Delegated Report

Householder Planning Application

Planning Application No: 20220537

Location: 63 Harden Road Northfleet Gravesend Kent

Extracts from SPG4

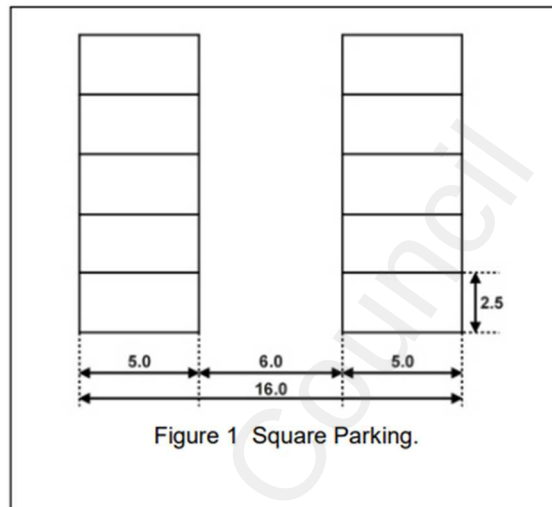
“Supplementary Planning Guidance SPG4 issued by Kent County Council and adopted by Gravesham Borough Council requires each parking space to be 5 metres deep by 2.5 metres wide generally, but the width increases to 2.7 metres when adjacent to an enclosed boundary to provide the space that would be borrowed from an adjacent parking space when accessing the vehicle. Similarly a parking space length is increased to 6 metres in length when it is parallel to and immediately adjacent to the access to provide manoeuvring space. In locations such as demonstrated here there would need to be a 6 metres wide aisle to accommodate vehicle turning into and out of the space and there is insufficient space to provide this.

In terms of the depth of the car parking spaces, there may be some slight flexibility as Kent County Council have issued other, but not adopted guidance that a parking space may be 4.8 metres deep, this depth may just be possible on part of the front garden, but only sufficient for a single vehicle.

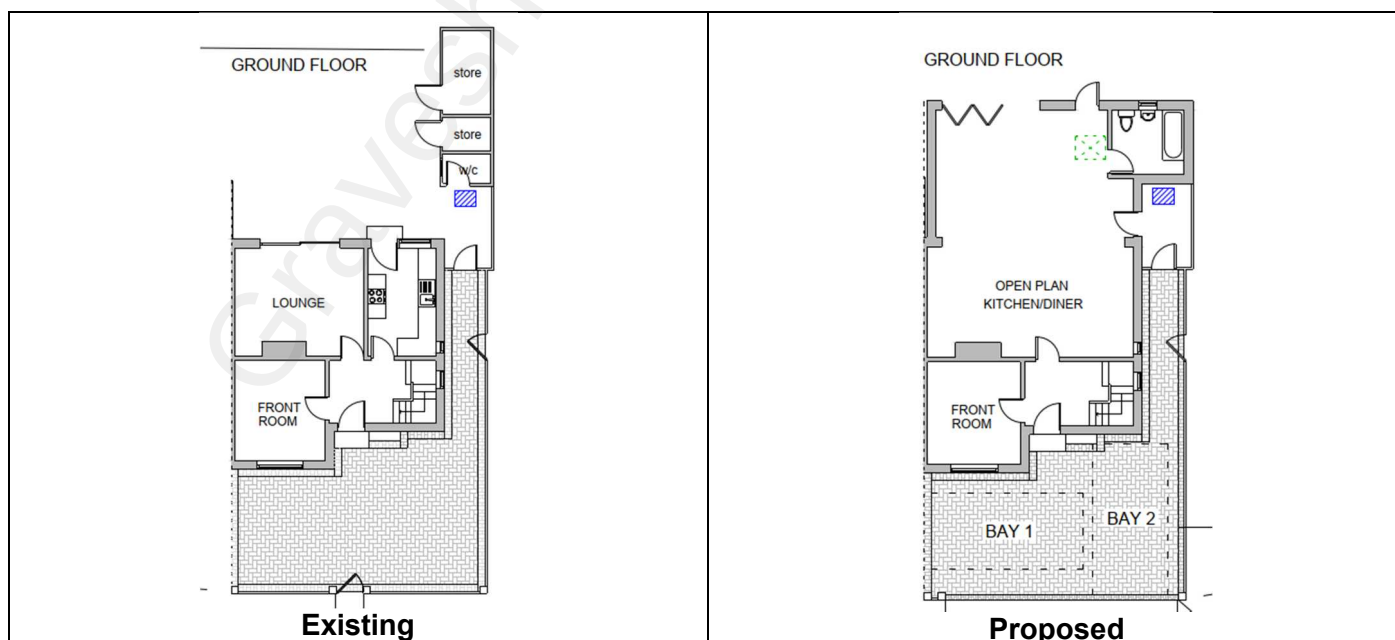
In design terms, the single storey extension extends beyond a side wall and is more than half the width of the original house. Although it is noted that the existing store is to be demolished to make room for the development, this extension would overwhelm the original dwelling and would almost double the building footprint as indicated by the floor plans below:

In addition to this, the proposed off-centre dual pitched roof is not sympathetic to the existing dwelling and the windows and doors are not aligned with the original house meaning it fails to give a sense of balance and proportion.

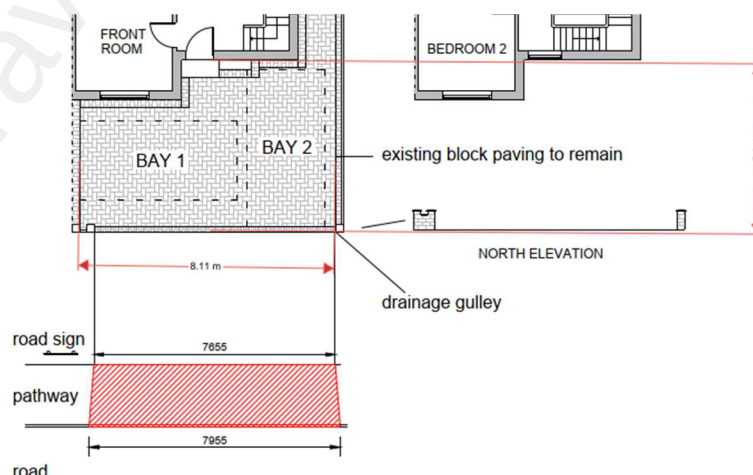
As shown by the measurements on the proposed plan below, there is insufficient space to park a vehicle and allow the additional 1.00m space to access the front door which is contrary to Policy CS11 - Transport, SPG 4 - KCC Parking Standards (2006) and KCC Vehicle Crossing Guidance Self Assessment (2018.)
